Classification	ISaGRAF FAQ-088						
Author	Spike Huang	Version	1.0.0	Date	Feb. 2008	Page	1 / 1

Function Modifications: The W-8347/8747, uPAC-7186EG, I-8x37-80, I-8xx7 and I-7188EG/XG with S256/512 and X607/608 no longer support old retain method, please change to use the better new retain method to retain variables.

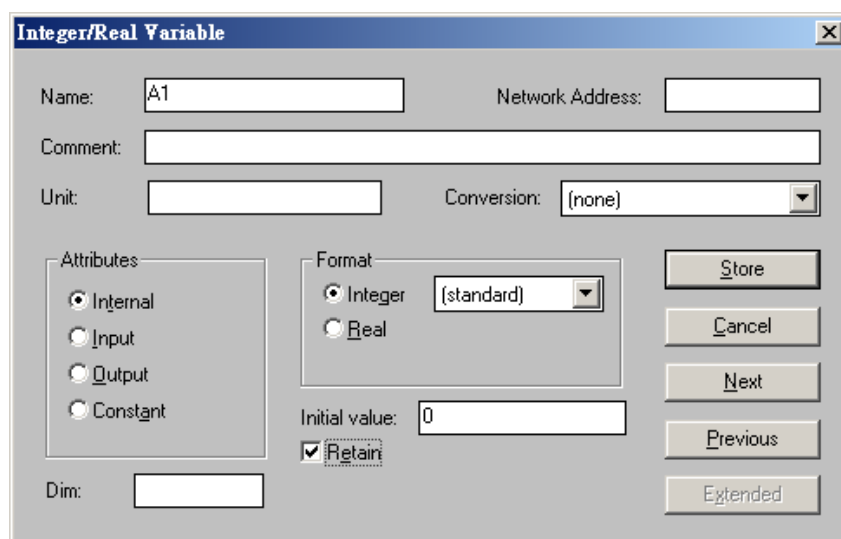
The W-8347/8747, uPAC-7186EG, I-8x37-80, I-8xx7 and I-7188EG/XG with S256/512 and X607/608 no longer support the old retain method since their following driver version.

The below figure shows the old retain method that is no longer supported by the above driver version. (Old method should check the “Retain” options)

Please DO NOT check the “Retain” options when using new retain method. New retain method should call function of “Retain_B”, “Retain_N”, “Retain_F”, “Retain_T” in the first PLC scan to retain variables. For more information about the new retain functions, please refer to FAQ-074:
